## ADMINISTRATIVE SHORT PLAT REPORT & DECISION

**Project Name:** 2001 Union Ave Short Plat

**Project Number:** LUA14-000916, SHPL-A

**2001 UNION AVE SHORT PLAT  
GRADING AND UTILITY PLAN  
RENTON, WASHINGTON**

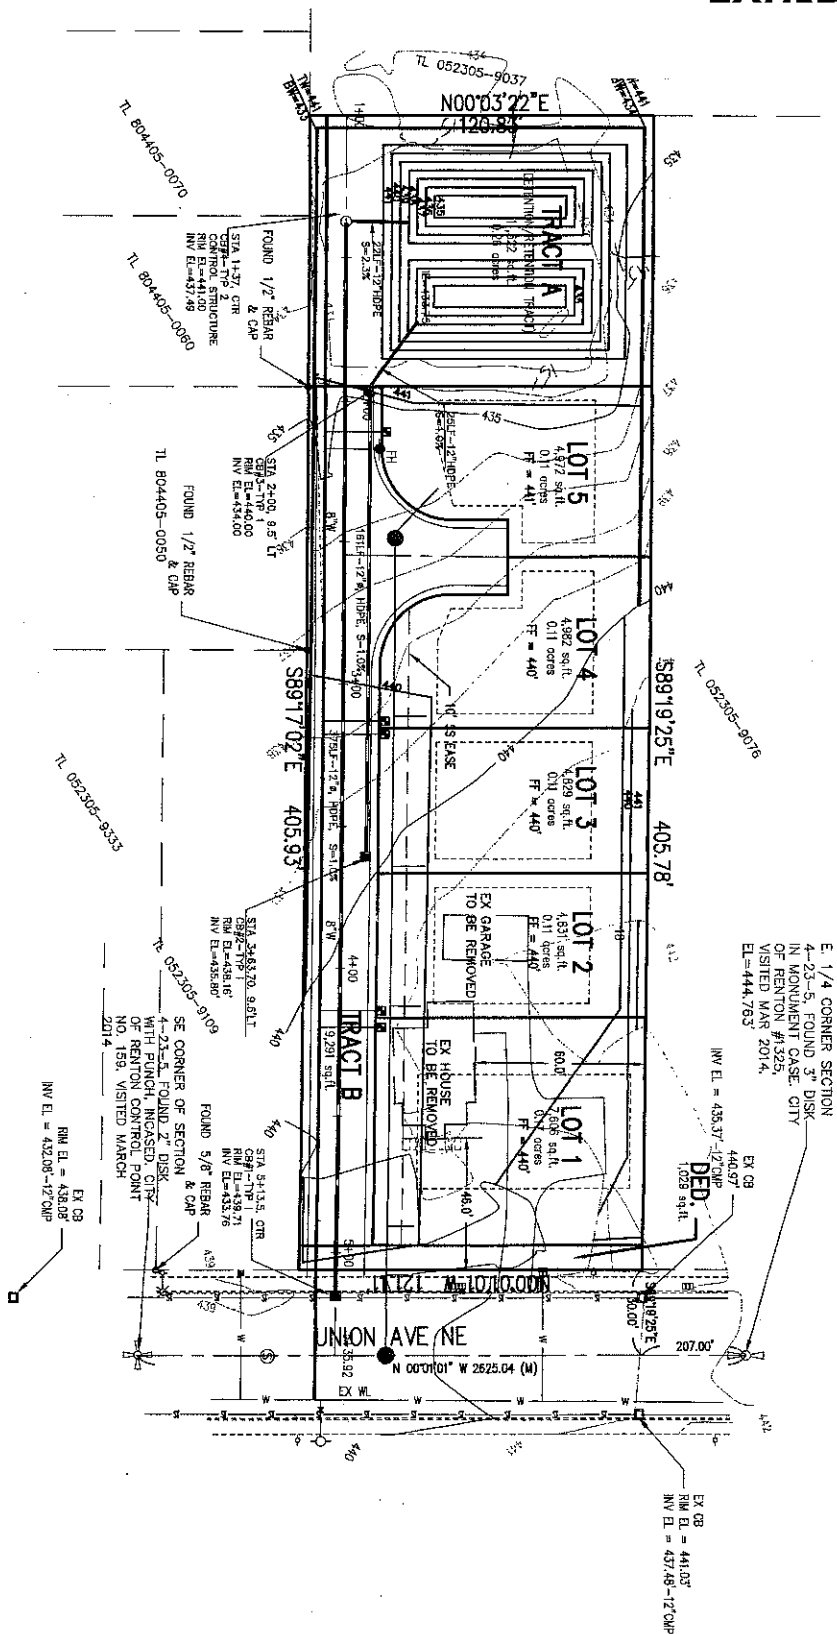
1. The project proposes the extension of about 8-inch water main within the proposed private road of the short plat, extending from the existing water main on Union Ave NE up to the west property line of the short plat. The water main must be located within the paved access and must be located at a minimum separation of 4 feet from the paved edge.

2. Since the proposed water main extension will cross the Seattle Public Utility 36" diameter water main on Union Ave NE, the applicant will have to contact the Seattle Public Utility regarding their clearance requirements.

3. The project includes the installation of a fire hydrant near the hammer head of the proposed private road. An additional fire hydrant is required at the intersection of the proposed private road with Union Ave NE.

1. Sewer service is provided by the City of Renton. There is an 8-inch sewer main in Union Ave NE. The proposed conceptual utility plan includes extending the sewer main, within the short plat, to the eastern boundary of Lot 5. A 10 feet wide sanitary sewer public easement is proposed for the sewer service. Additionally, a 10 feet wide public sewer easement is required to be provided that will extend to the west property line of the short plat. A City of City of Renton Public Utility easement is required over the entire private road and extending up to the west property line of the short plat.

**2001 UNION AVE SHORT PLAT  
TOPO & LANDSCAPING PLAN**

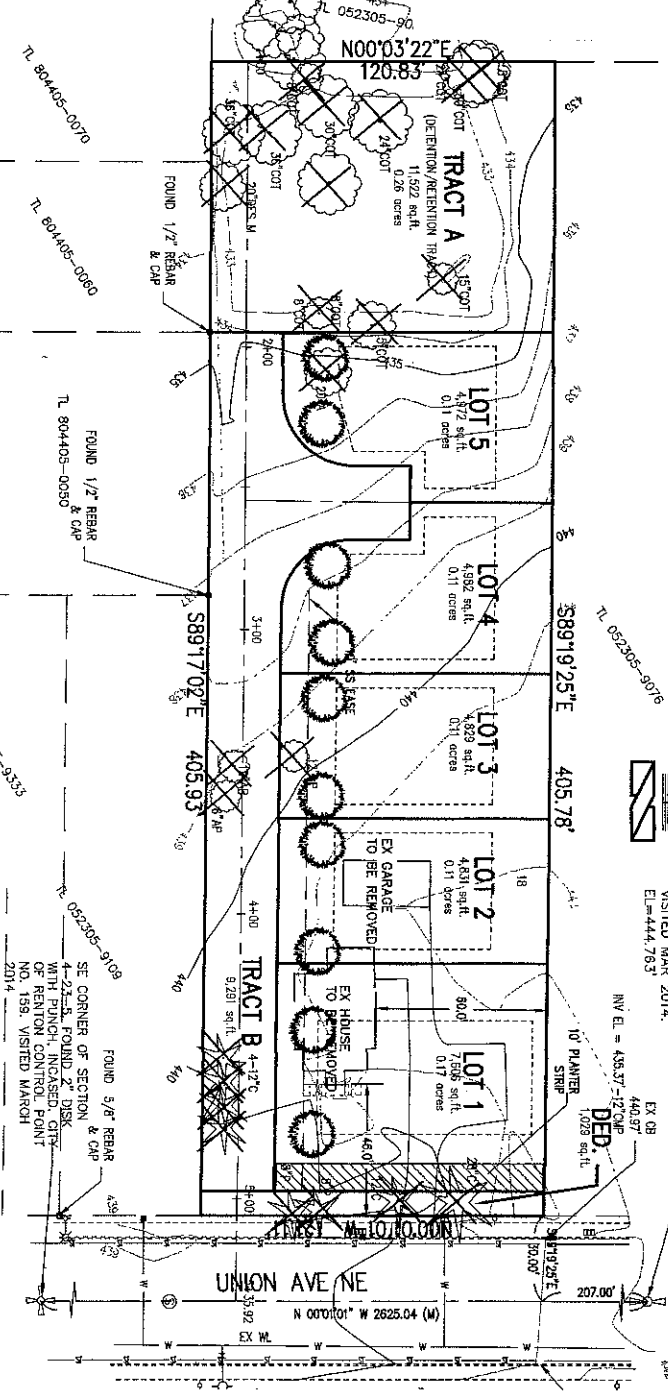
<b>Note 1</b>	<p><b>Tree Retention:</b> The City's adopted Tree Retention and Land Clearing Regulations require the retention of 30 percent of trees in a residential development.</p> <p><i>Staff Comment: There are a total of 24 significant trees located on the project site. Of those 4 are located within an area to be dedicated as right-of-way along Union Ave NE, and 6 are located within the proposed private street, which results in a total of 14 protected trees remaining on the project site. No trees are proposed for retention. To comply with the Tree Retention requirements, the applicant would be required to replant 24 minimum 2-inch caliper trees around the project site. The proposal includes the replacement of 10 2-inch caliper trees, therefore an additional 14 2-inch caliper trees are required to comply with the Tree Retention requirements. Staff recommends as a condition of approval that a revised Tree Retention plan in compliance with the City's adopted Tree Retention and Land Clearing Regulations be submitted at the time of Construction Permit application for review and approval by the Planning Division project manager.</i></p>

3. A detailed landscape plan shall be submitted at the time of Construction Permit application for review and approval by the Planning Division project manager. The 10-foot landscaped strip shall be installed prior to final short plat approval and the front yard trees shall be installed prior to final occupancy for the new single family residences.

4. A revised Tree Retention plan in compliance with the City's adopted Tree Retention and Land Clearing Regulations shall be submitted at the time of Construction Permit application for review and approval by the Current Planning project manager.

8. A revised landscape plan shall be submitted at the time of Construction Permit review showing the required 15-foot wide landscape strip around the stormwater pond. The landscape plan shall be submitted to the Current Planning project manager for review and approval prior to construction permit issuance. The landscaping shall be installed prior to the recording of the final short plat.
